Subject: On-Call Asbestos, Lead, Air Quality & Demolition Compliance  
Agreement No. 8.07-01 (18)  
HazMat Inspection – Signage Replacement, Route 9, 15 & SR571 Connector, Cromwell & Berlin, CT  
ConnDOT Assignment No. 519-5849  
ConnDOT Project No. 7-189  
TRC Project No. 289951.5849.0710

**Subject:** Preliminary Design Review Request  
Project No. 0007-0189  
Replacement of Existing Signing on Routes 9  
(MP 24.65 to MP 34.48), 5/15 (MP 68.02 to  
73.40), & SR 571 (MP 00.00 to 01.25)  
Towns of Cromwell and Berlin  
**Date:** October 22, 2018

## PROJECT 7-189 ROUTE 9, 15, & SR 571 HIGHWAY RESIGNING

## Plans For REPLACEMENT OF HIGHWAY SIGNING ON ROUTE 9, 15, & SR 571 CONNECTOR

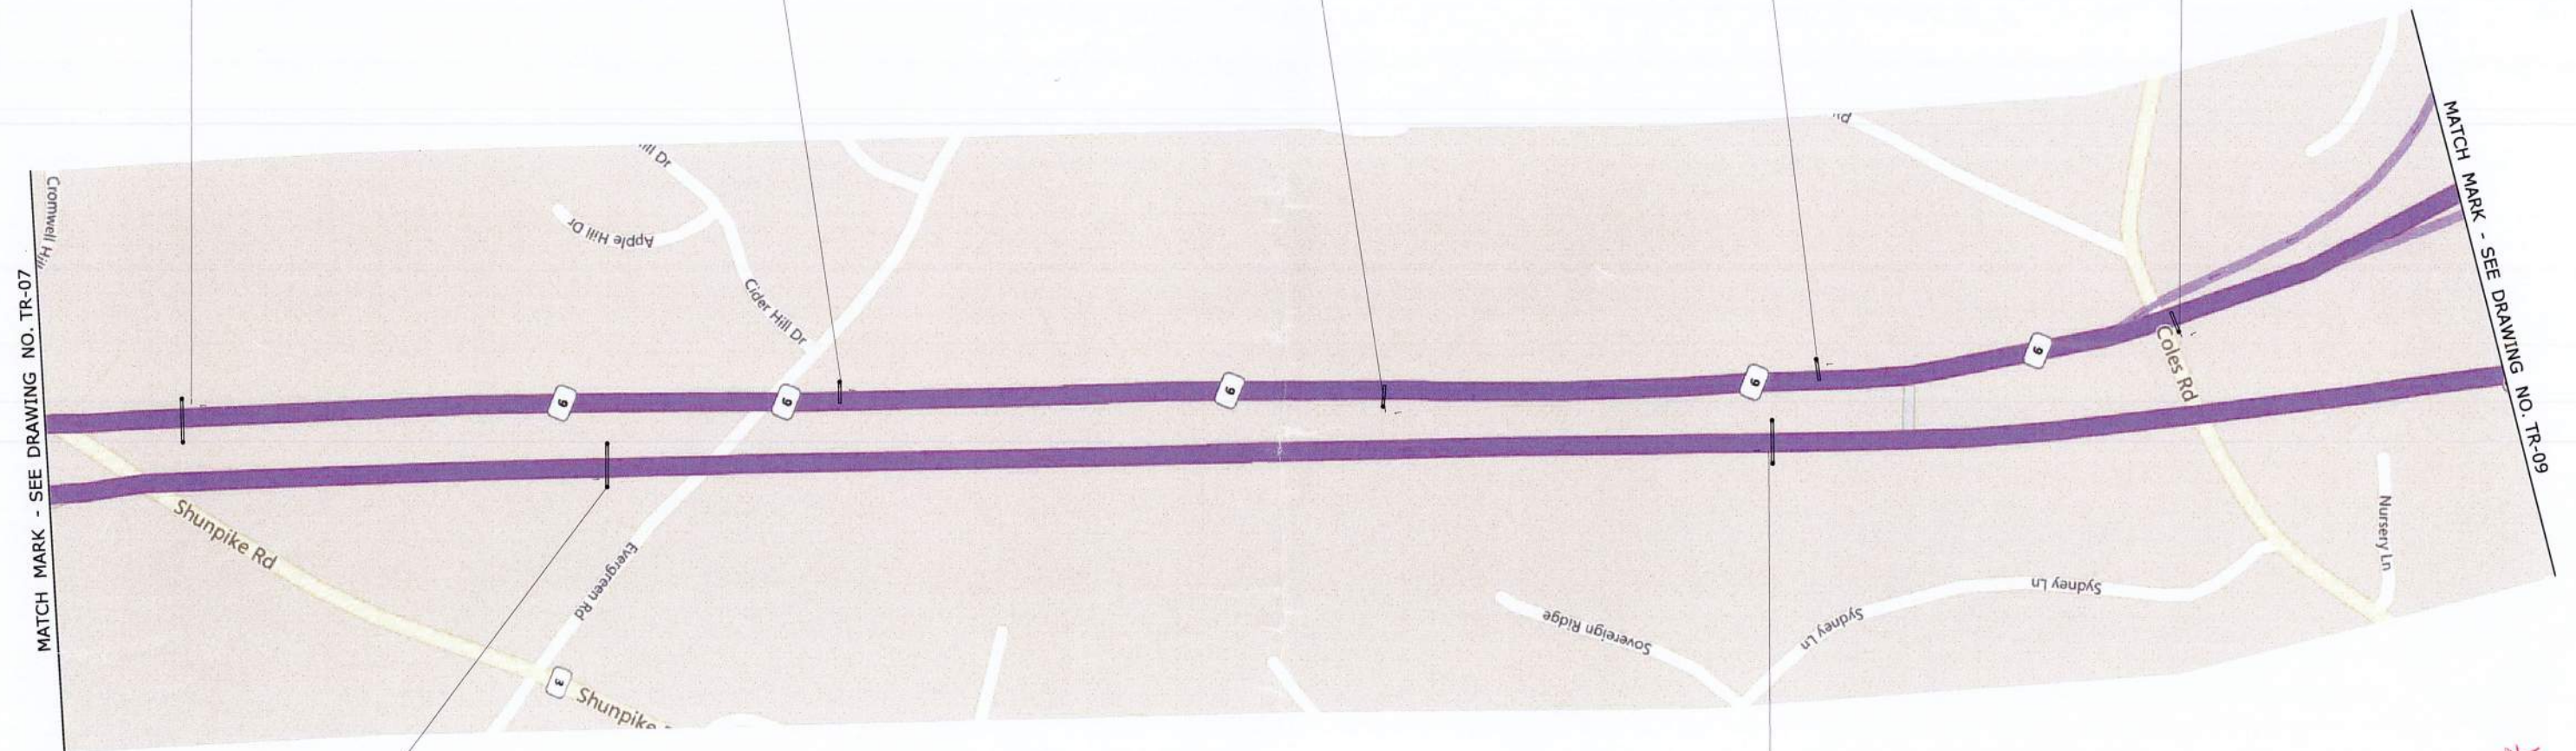
-unpainted  
 -NO ACM

0095-033-28.50A : 204.000 x 84.000  
 ID: 803  
 SSN: 21082  
 -Green paint  
 -NO ACM

-SAME LIGHT GREEN PAINT  
 -NO ACM  
 ND 0.10 0.02

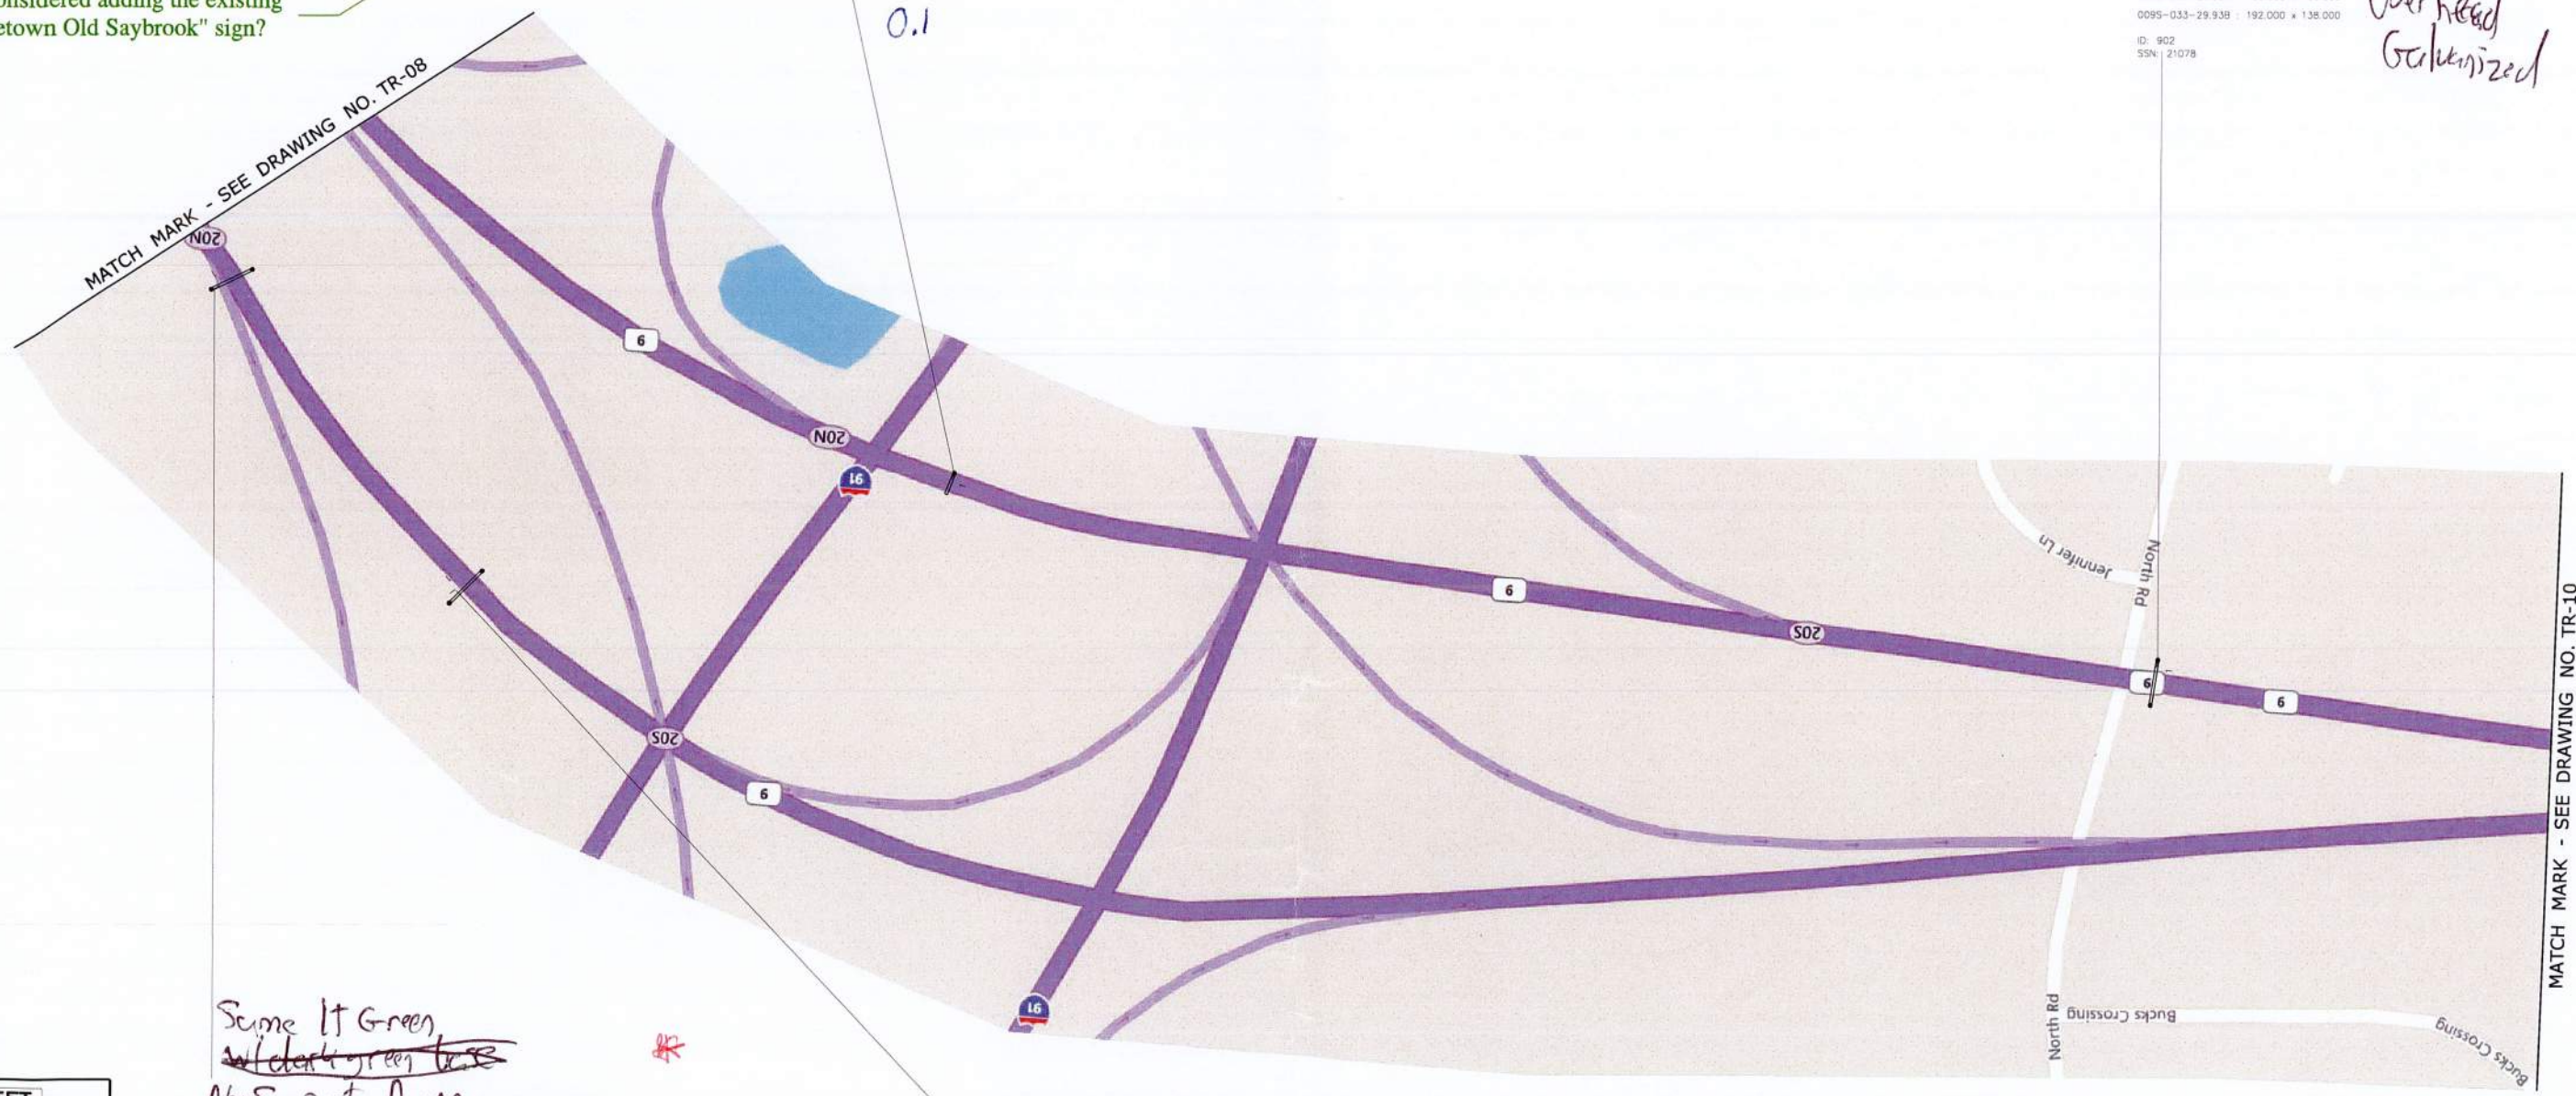
*PAINT SAMPLE*  
*NO ACM*  
*SAME LIGHT GREEN PAINT ON GALVANIZED*

*Overhead Galvanized*

*Some Lt Green*  
~~*with dark green base*~~  
*No Suspect ACM*

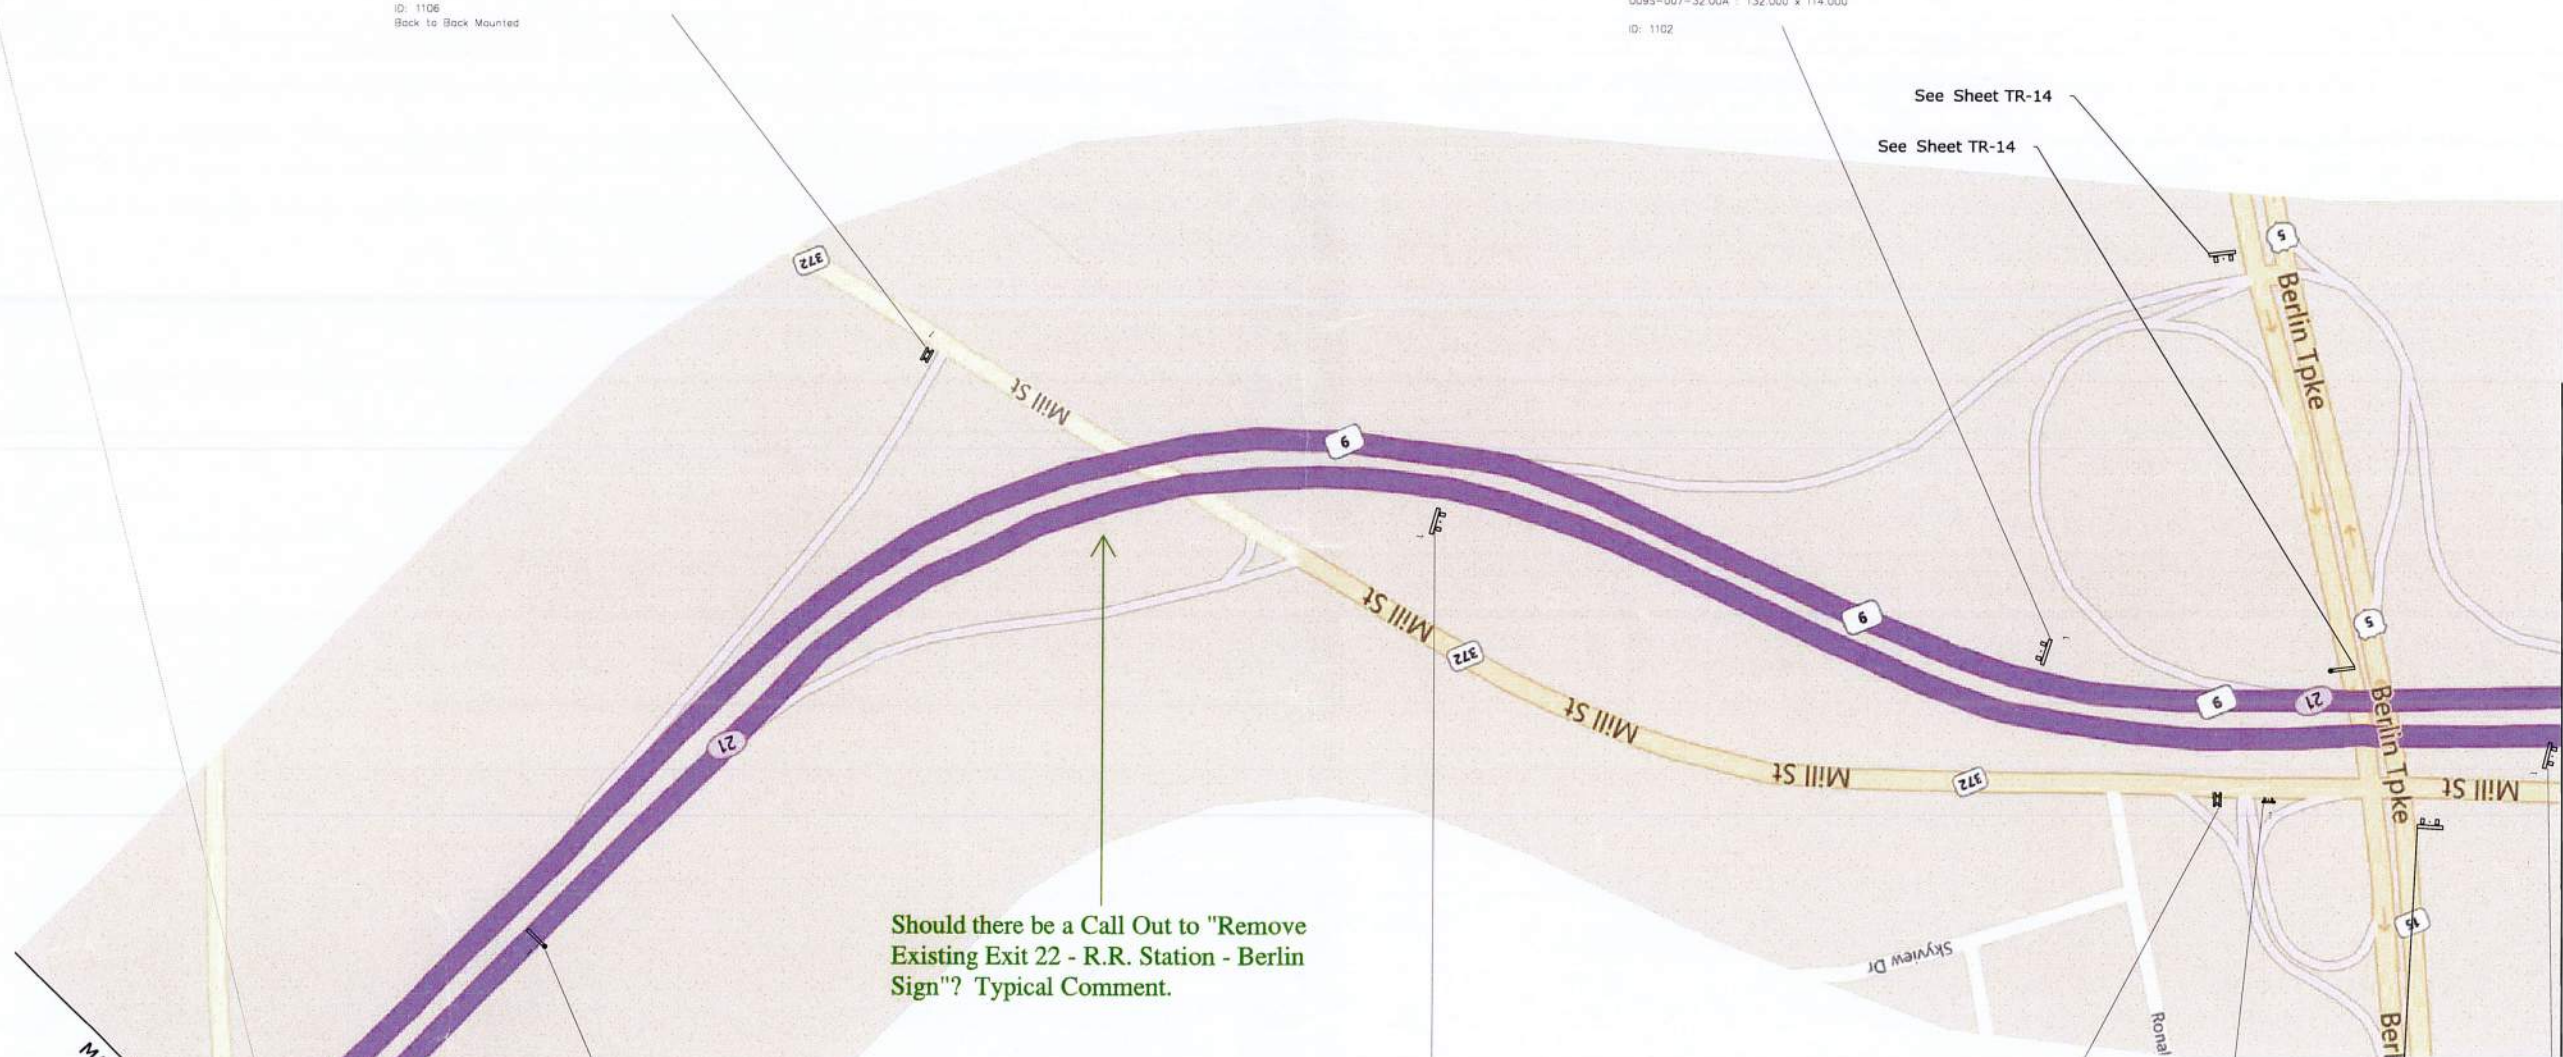
*Galvanized  
No cowl*

*Galvanized  
No cowl*

*couldnt find*

Should there be a Call Out to "Remove Existing Exit 22 - R.R. Station - Berlin Sign"? Typical Comment.

*No suspect ACM  
Some Hgreen*

PROJECT NO. 0007-0189  
DRAWING NO. TR-11  
SHEET NO.

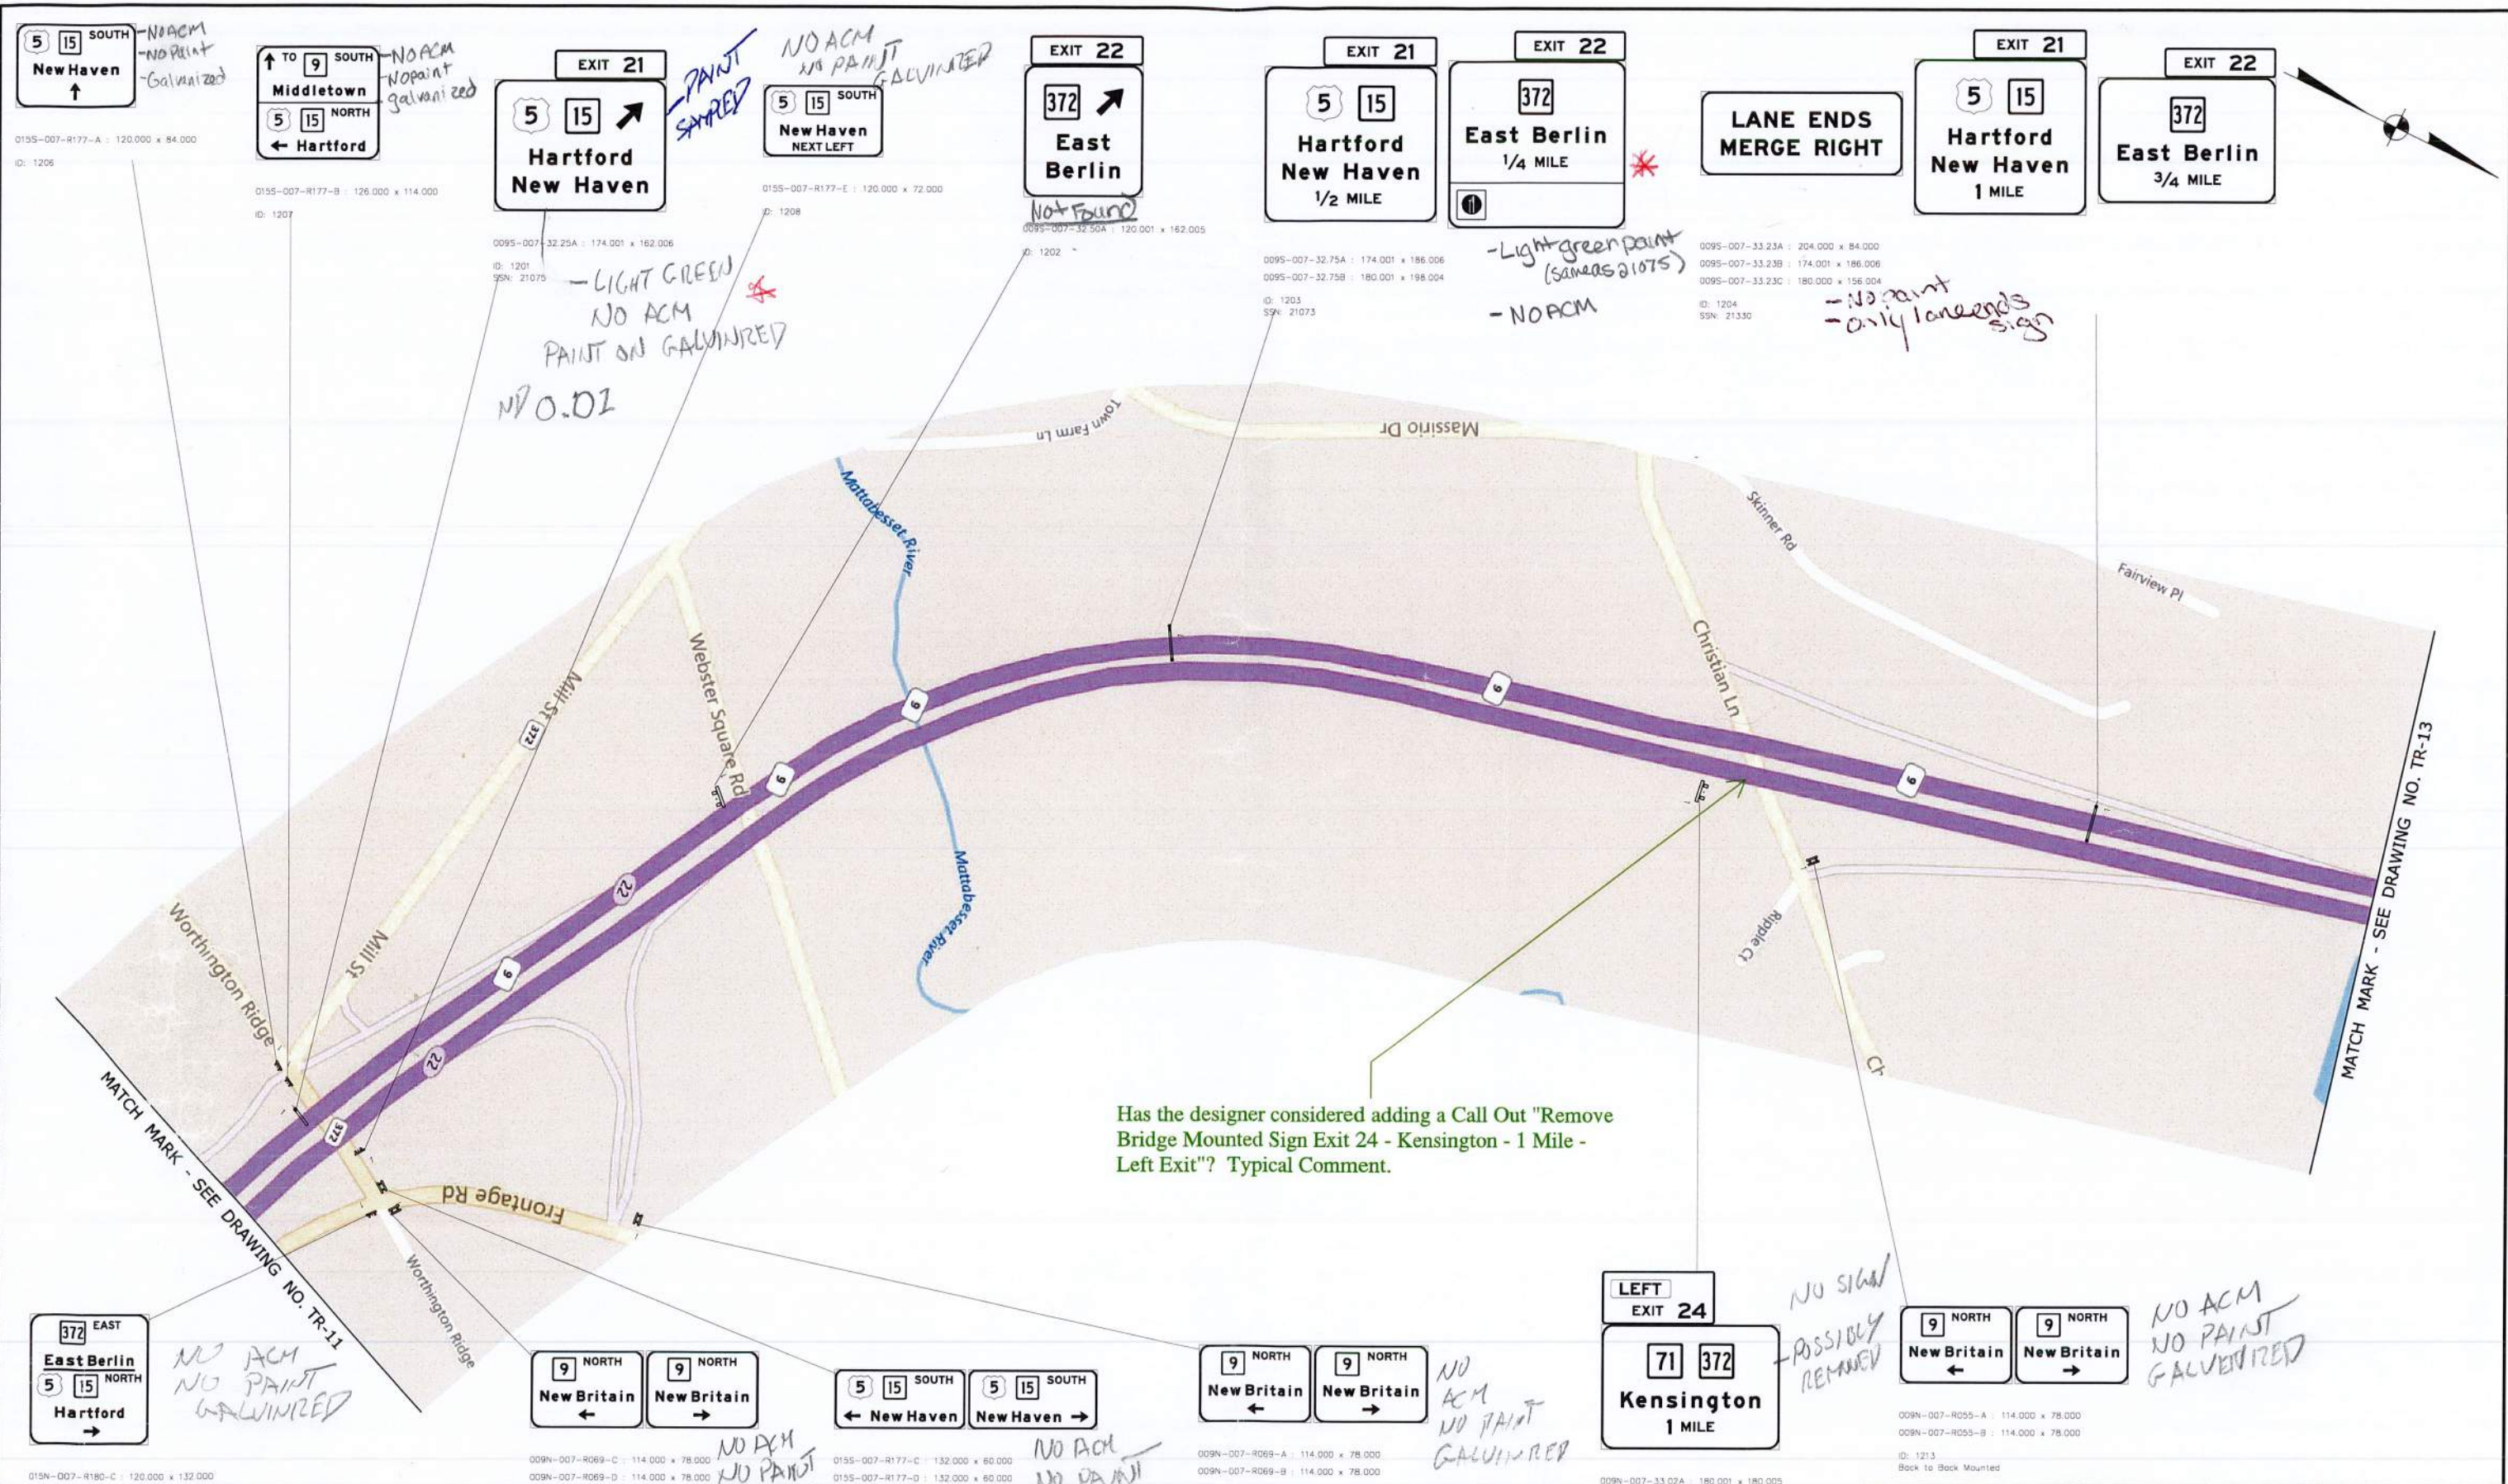
Has the designer considered adding a Call Out "Remove Bridge Mounted Sign Exit 24 - Kensington - 1 Mile - Left Exit"? Typical Comment.
